Watts Bar Nuclear Plant, Unit 1
Facility Operating License No. NPF-90
NRC Docket No. 50-390

Subject: **Watts Bar Nuclear Plant Unit 1 - Technical Specifications Change -
Main Control Room Chiller Completion Time Extension**

Pursuant to 10 CFR 50.90, the Tennessee Valley Authority (TVA) requests a Technical Specifications (TS) change, WBN-TS-09-16, for Watts Bar Nuclear Plant, Unit 1, Operating License NPF-90.

**SKETCH A
 TEMPORARY COOLING TACF DURING REPLACEMENT OF 6.9 KV SHUTDOWN BOARD ROOM CHILLERS.**

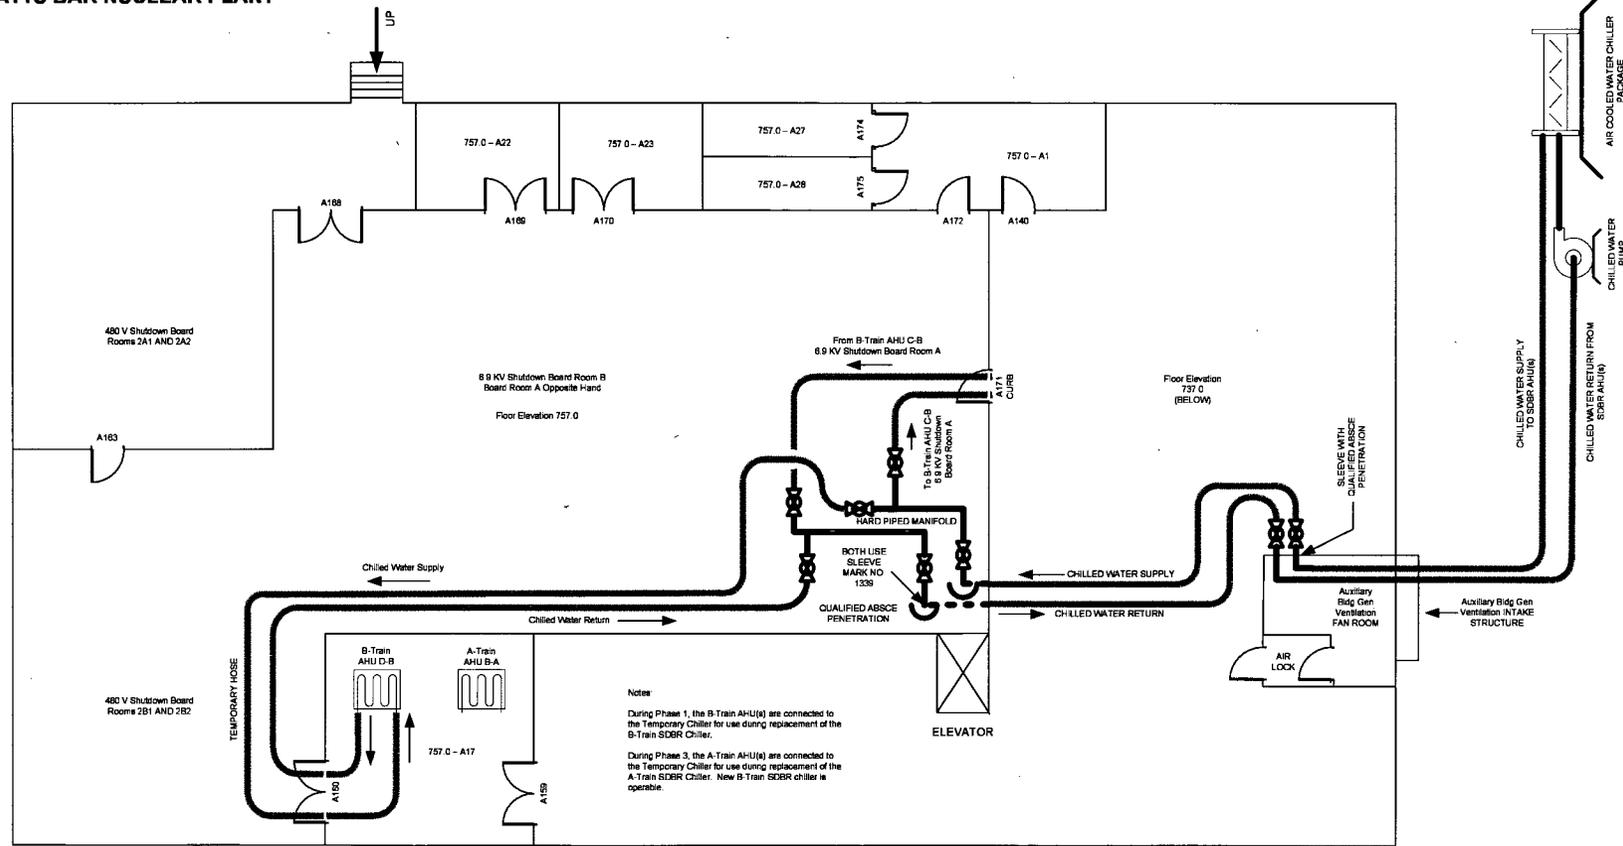
SDBR Temporary Air Conditioning Equipment Description - Reference Sketch A

As shown in Sketch-A, the temporary chilled water system is to be installed and maintained in "standby status" in order to maintain the temperature of the spaces listed above below their design basis limit of 104°F in the event the OPERABLE chiller fails during replacement activities concurrent with a DBA. The design bases temperature for the SDBR elevation is defined by WBN Environmental Data Drawings (EDDs) which list the temperature, humidity, pressure, and dose limits for various operational conditions and post-LOCA conditions. The major components of the temporary chilled water system include:

Notes:
 During Phase 1, the B-Train AHU(s) are connected to the Temporary Chiller for use during replacement of the B-Train SDBR Chiller.
 During Phase 3, the A-Train AHU(s) are connected to the Temporary Chiller for use during replacement of the A-Train SDBR Chiller. New B-Train SDBR chiller is operate.

SKETCH B
TEMPORARY COOLING TACF DURING REPLACEMENT OF MAIN CONTROL ROOM CHILLERS

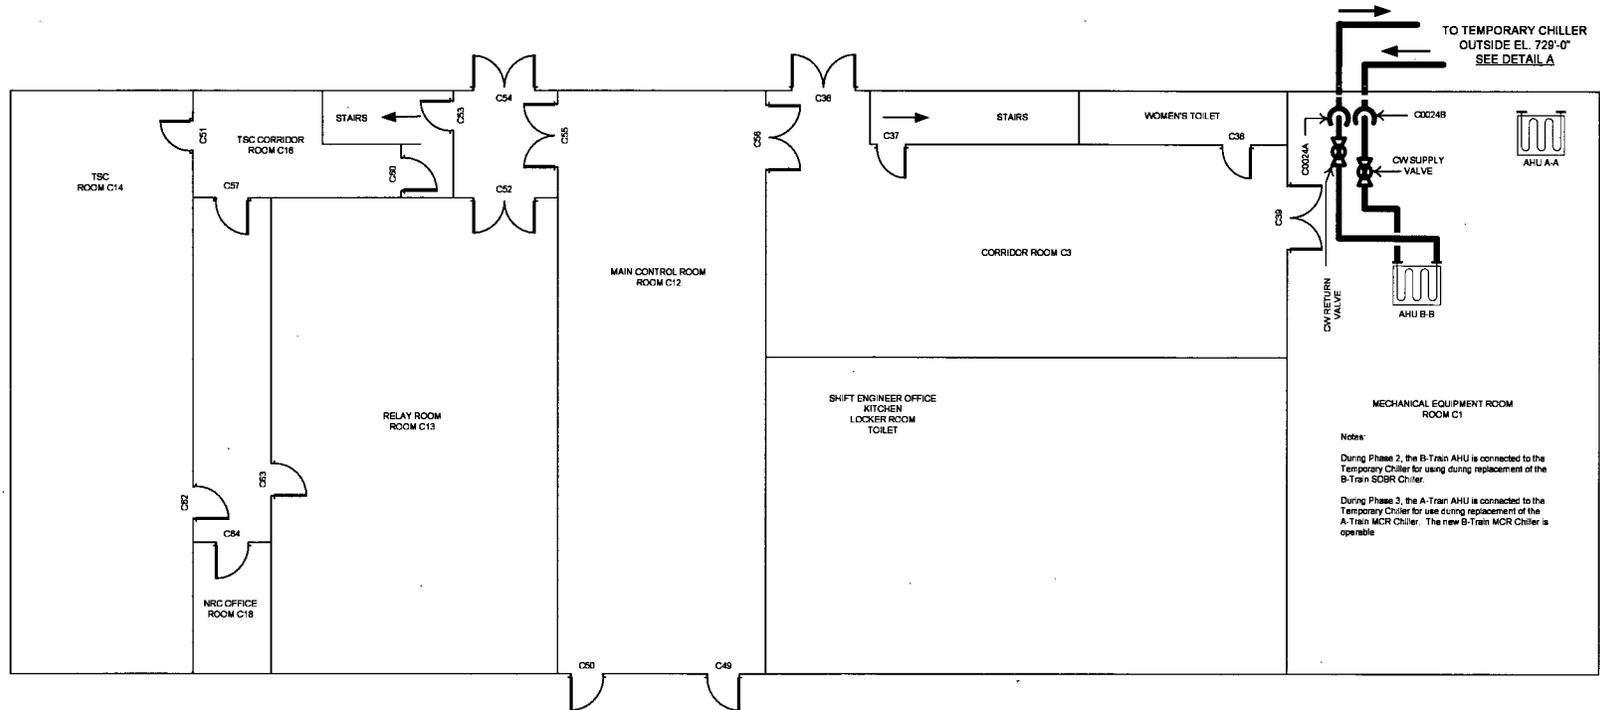
MCR Equipment Description - Reference Sketch B

As mentioned above a temporary air-cooled chiller package and chilled water pump will be stationed in the yard area (Elevation 729). The non-safety related chiller package and chilled water pump will be powered from non-safety related 480 Volt ac sources within the area. A backup diesel generator will be provided as a backup power source if needed (see Section 2.1.4).

Supply and return hoses will be utilized for routing the chilled water from the temporary chilled water package to the AHUs in the Control Building. Existing sleeves located on elevation 755.0 which are part of the MCRHZ boundary will be utilized for routing the chilled water supply and return hoses to the train-B MCR AHU located in the Mechanical Equipment Room. Two manual isolation ball valves, one for each penetration through the MCRHZ boundary will be provided for isolation purposes. Connection to the AHU coils will be made by isolating the chilled water piping, removing the flex hoses between the AHU coils and the chilled water piping and then connecting the temporary chilled water supply and return hoses to the AHU coils using existing flange connections.

Notes:
 During Phase 2, the B-Train AHU is connected to the Temporary Chiller for use during replacement of the B-Train SDBR Chiller.
 During Phase 3, the A-Train AHU is connected to the Temporary Chiller for use during replacement of the A-Train MCR Chiller. The new B-Train MCR Chiller is operable.
